Traffic Engineering Letter

To	Platting 88 Pty Ltd	Date	17 April 2026
Prepared by	Kevin Liu, Modus Traffic Engineer	Approved by	Harj Singh, Modus Executive Director (RPEQ 22364)
Location	160 Miles Platting Road, Eight Mile Plains		
Subject	Proposed Subdivision Development - Traffic Engineering Letter		
Status	Final	Attachments	Appendix A: Council Further Advice Appendix B: Revised Development Plans Appendix C: Swept Path Assessment

RE: Further advice

SHEET 2
SHEET 3

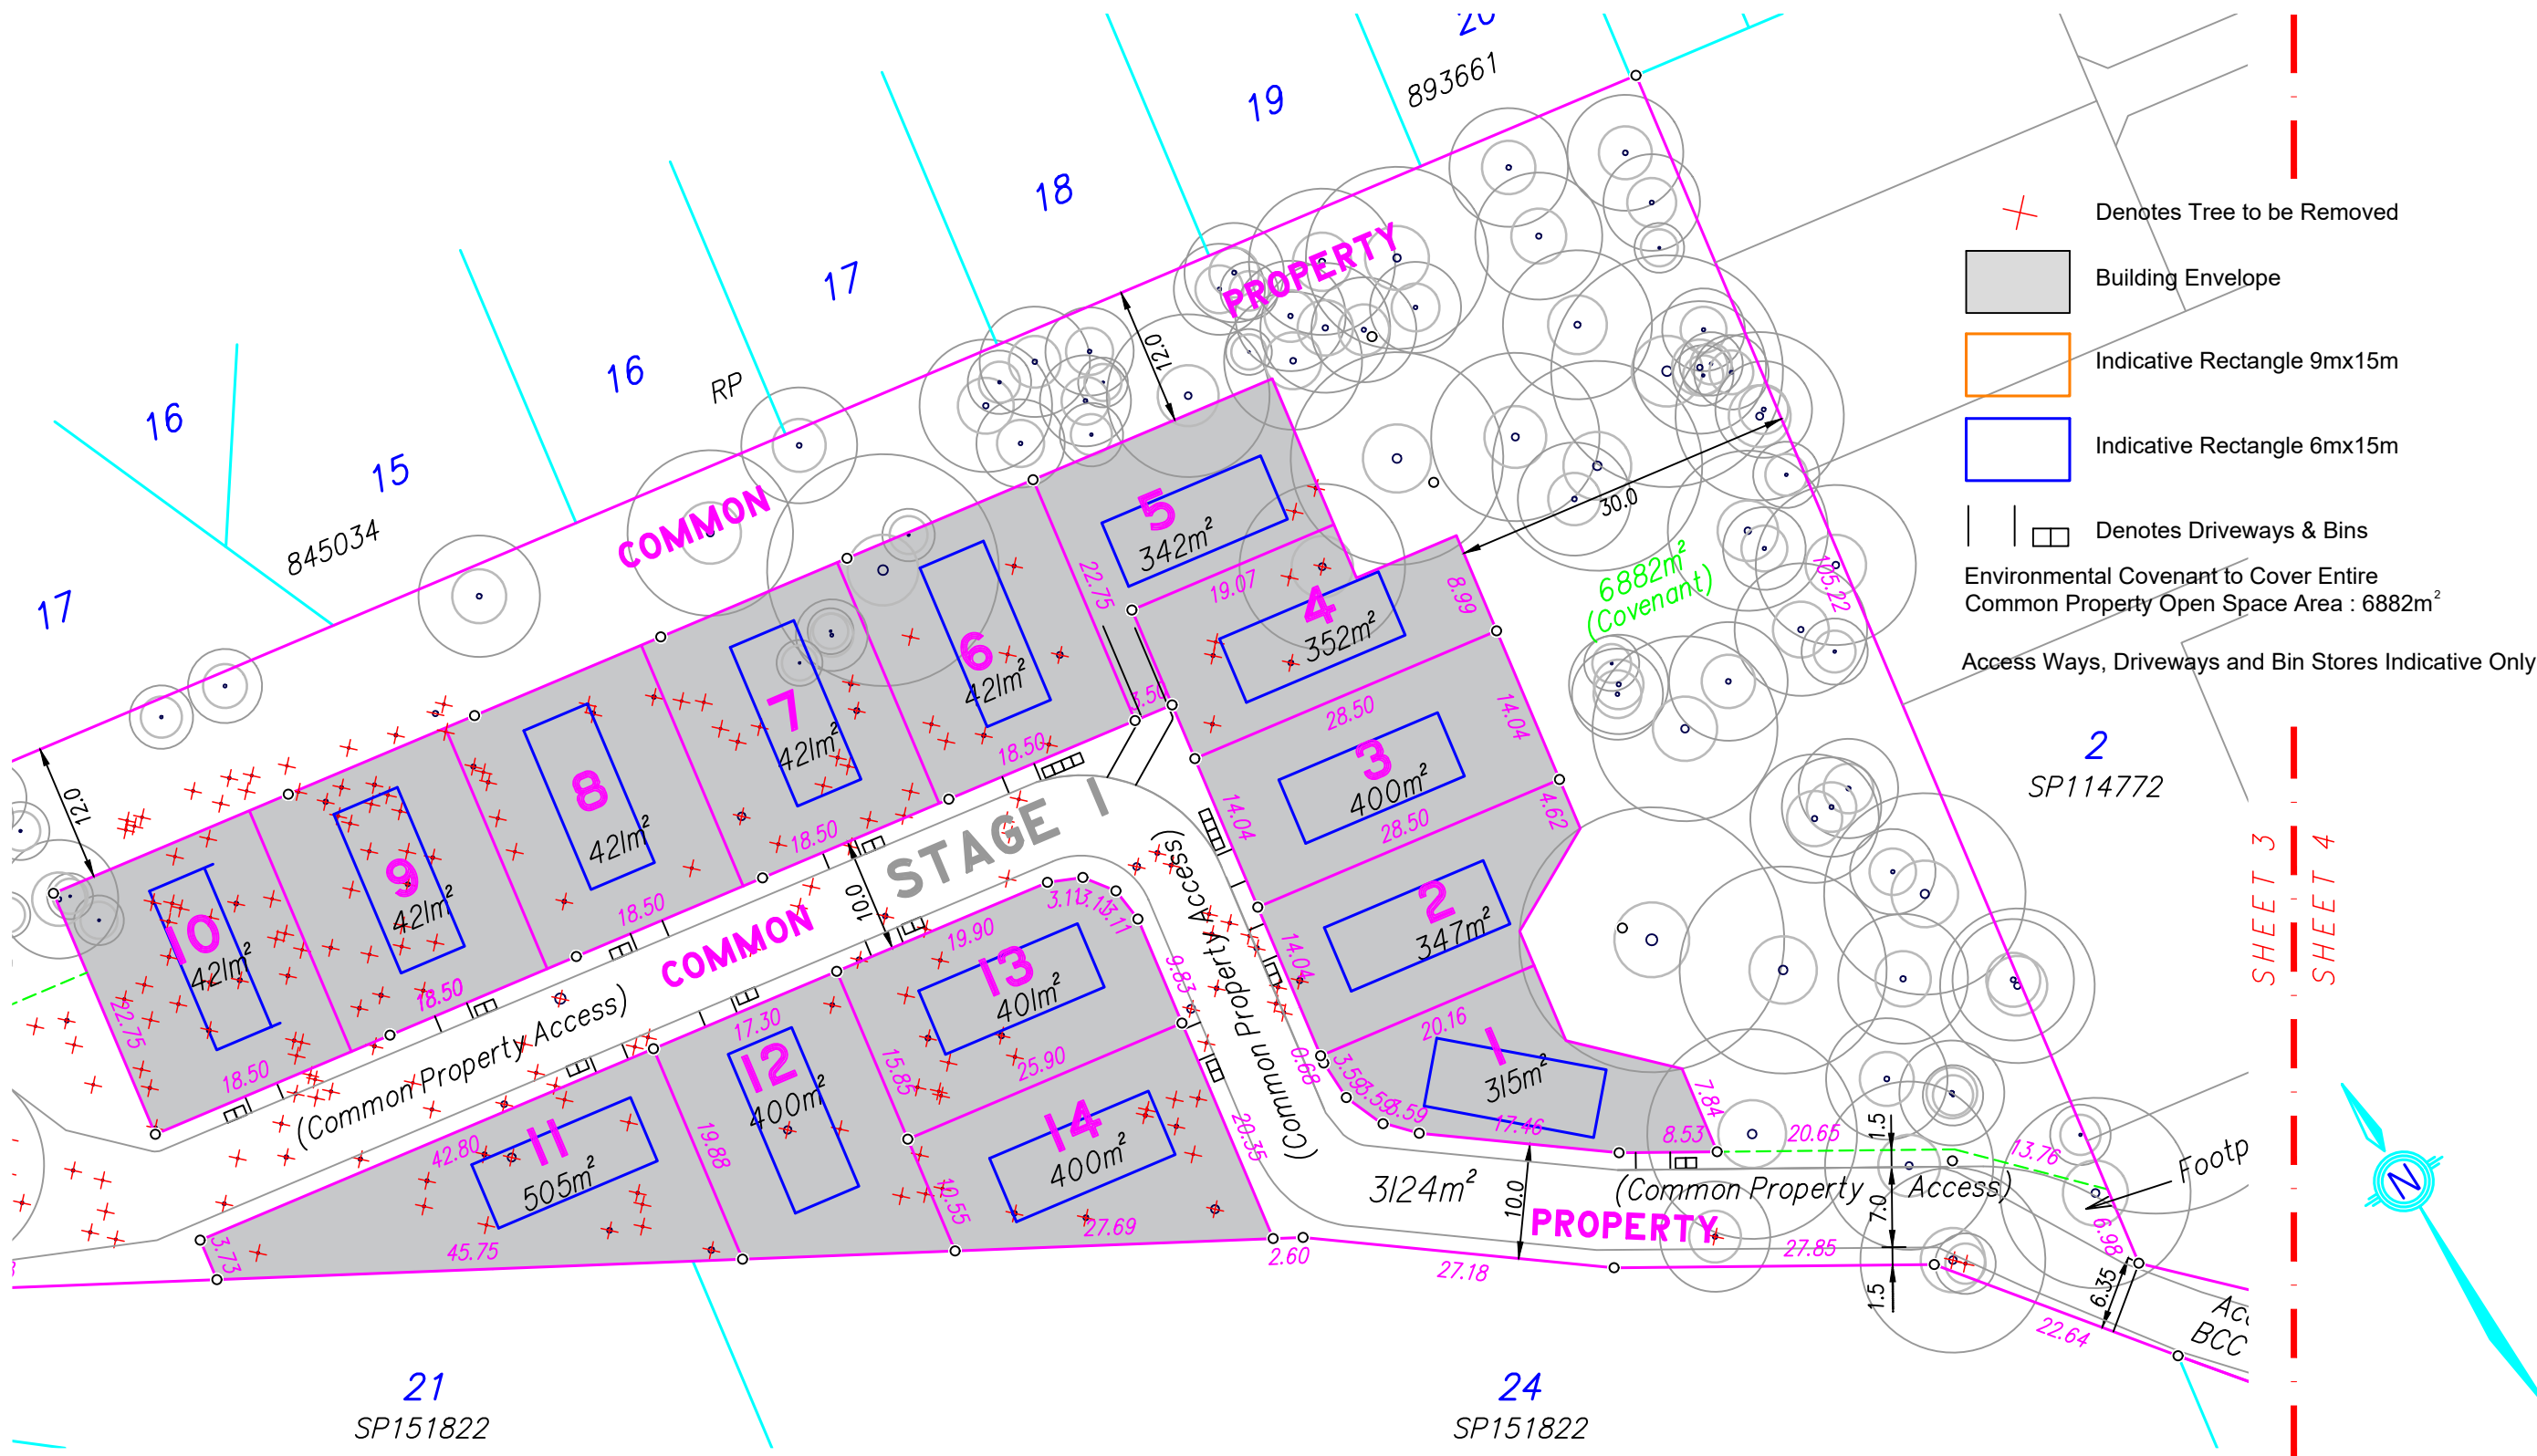
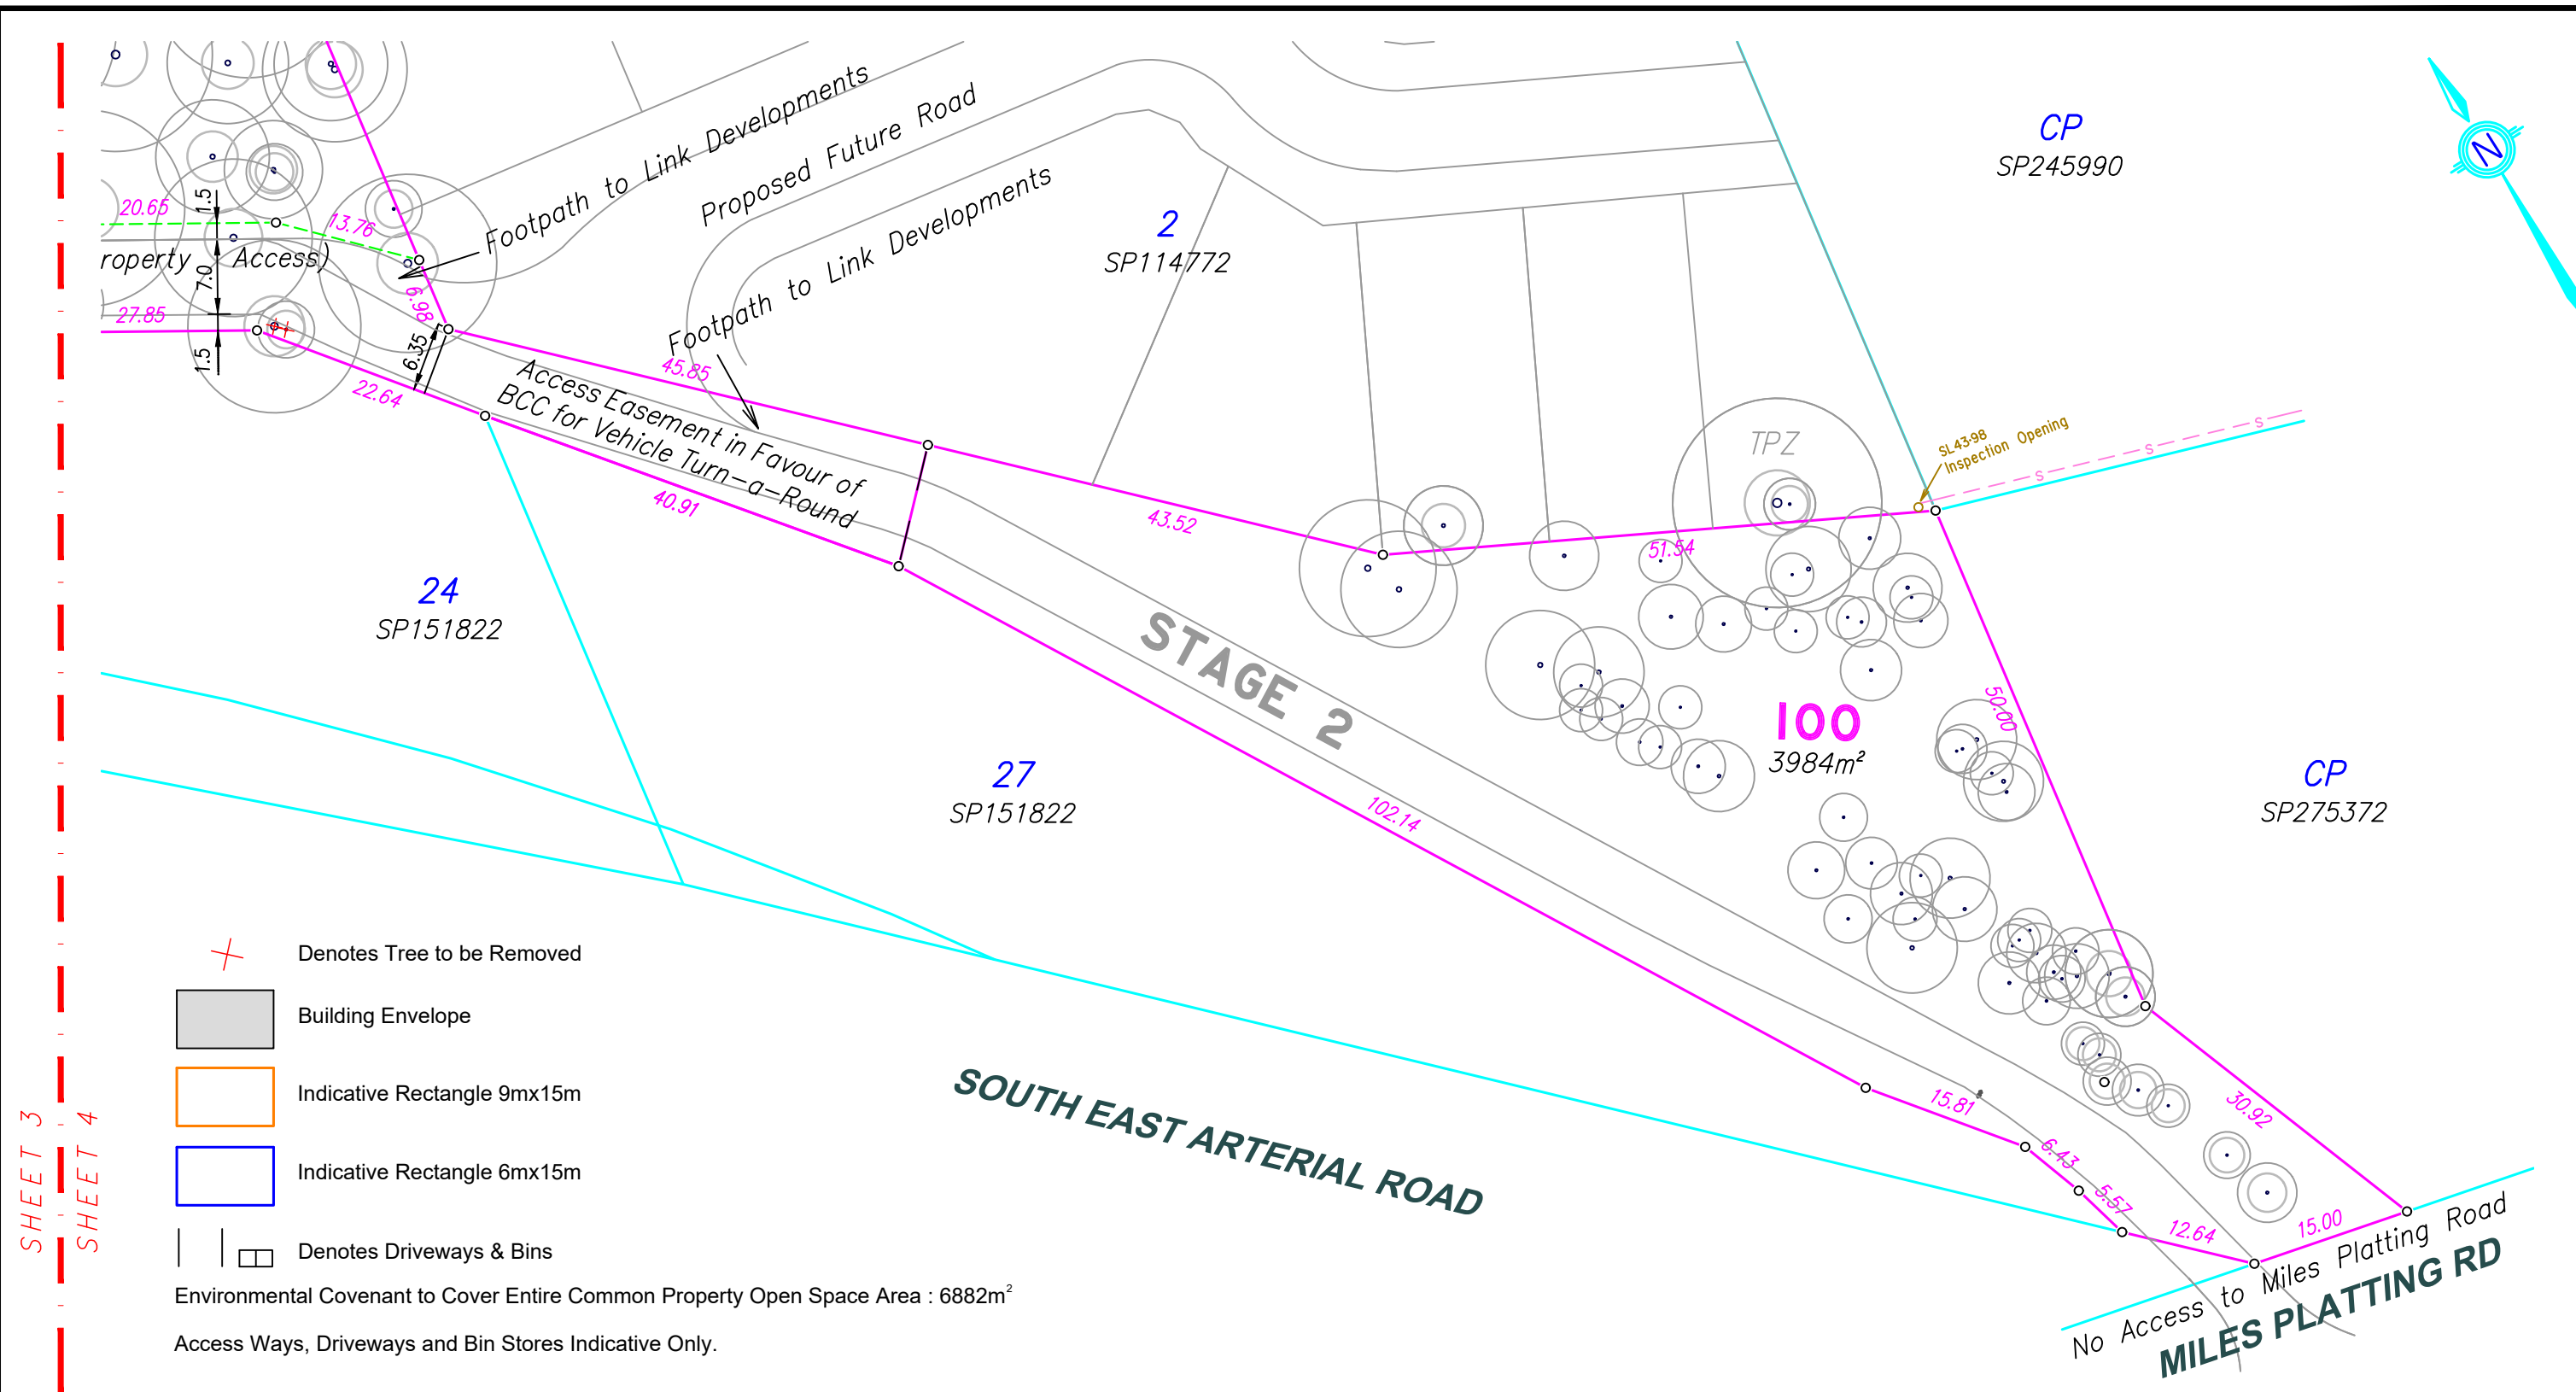
A review of the 'Structure Plan – Stage 1' and suite of 'Subdivision Proposal Plan – Stage 1 & Stage 2, and review of the 'Concept Services Layout Plan Sheet 1 – 3' has noted that the development has provided a minimum carriageway width of 10m. However, the pavement width is 7.5m wide, with a minimum verge width of 1.5m on the northern side and only a 1m wide verge width on the southern side in lieu of a 6.5m wide pavement width and 1.5m wide verge on both sides. Provide the following:

- a) Amended development plans which clearly demonstrates the development has been provided with a minimum 10m wide CTS, including a 6.5m carriageway width and 1.5m wide verges on the northern and southern sides of the carriageway.*

The amended development plans have been prepared to clearly demonstrate compliance with the required minimum 10.0m Community Titles Scheme (CTS) corridor width across the full extent of the proposed road.

The revised cross section now provides the carriageway width of 10m (min) as following:

- ▶ 6.5m (min) carriageway paved width,
- ▶ 1.5m (min) verge width on the northern side,
- ▶ 1.5m (min) verge width on the southern side.

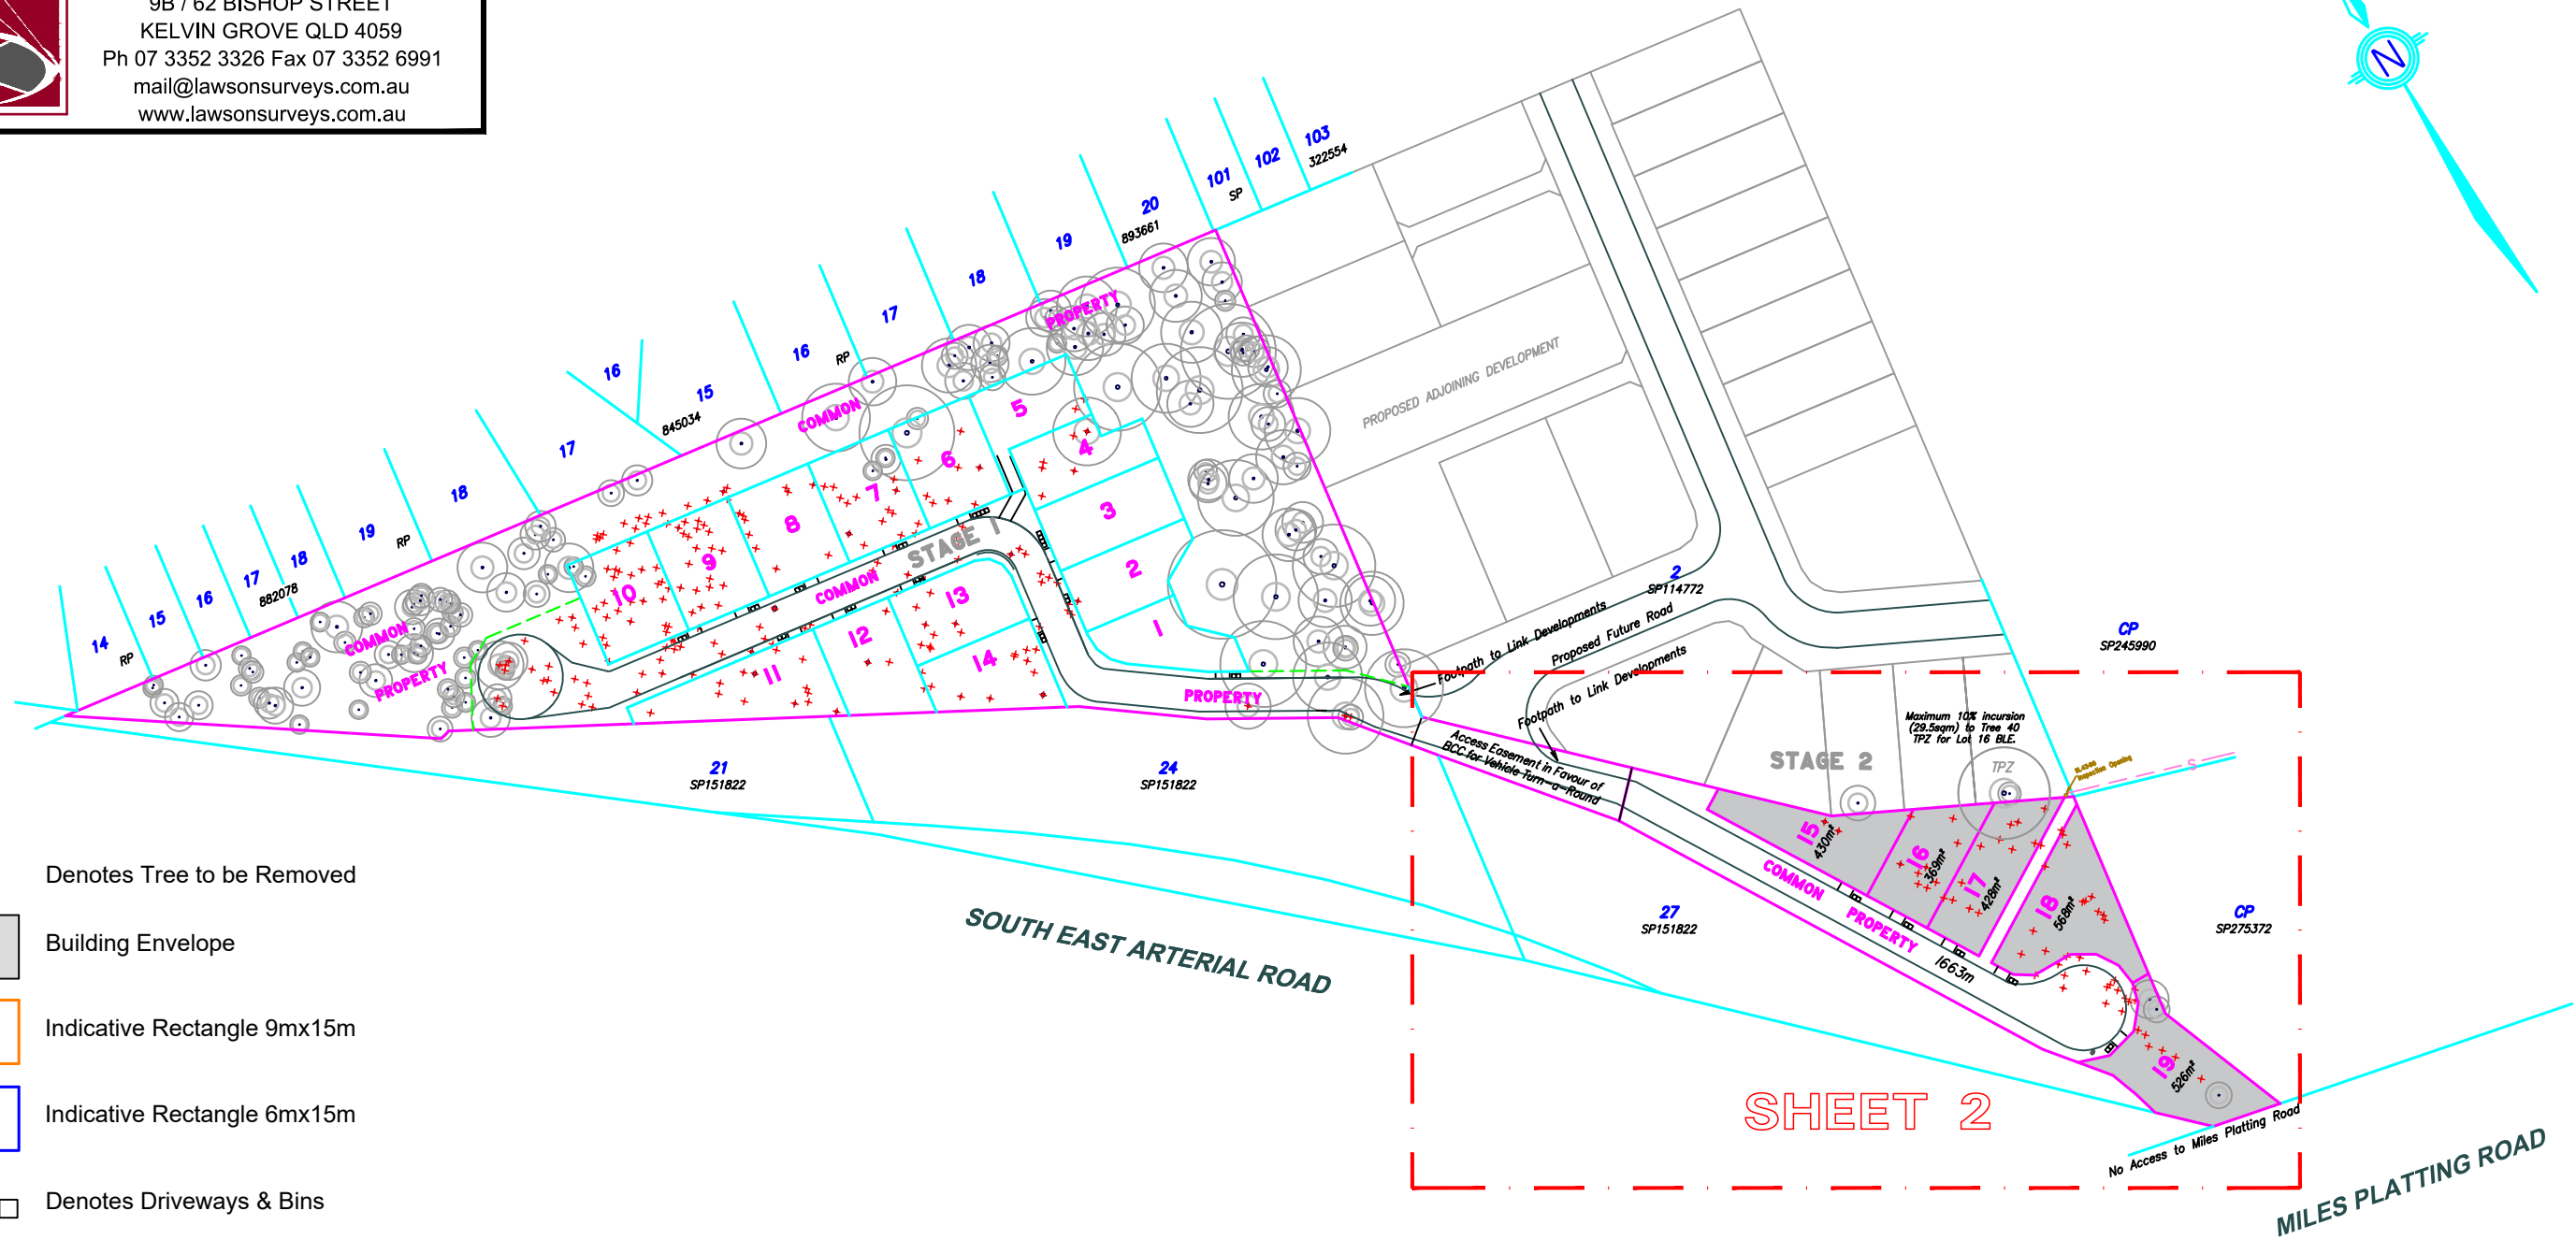
- a) Confirmation of the proposed sequencing of the development noting access to the site will need to be provided via approved development A006652684.*
- b) Amended plans which remove the proposed pedestrian and vehicle access from Miles Platting Road and illustrate the proposed cul-de-sac outcome currently shown as part of Stage 2.*

- ▶ Safe and compliant vehicular access,
 - ▶ A pedestrian safe path to the site,
 - ▶ Connectivity to the surrounding road network,
 - ▶ Appropriate linkage to the Eight Mile Plains Busway Station park and ride.
- b) Amended development plans have been prepared which:
 - ▶ Remove the previously proposed pedestrian and vehicle access to Miles Platting Road,
 - ▶ Stage 1 - turnaround provisions via a cul-de-sac and a 3-point turnaround within the easement (SK11),
 - ▶ Stage 2 - turnaround via the cul-de-sac.
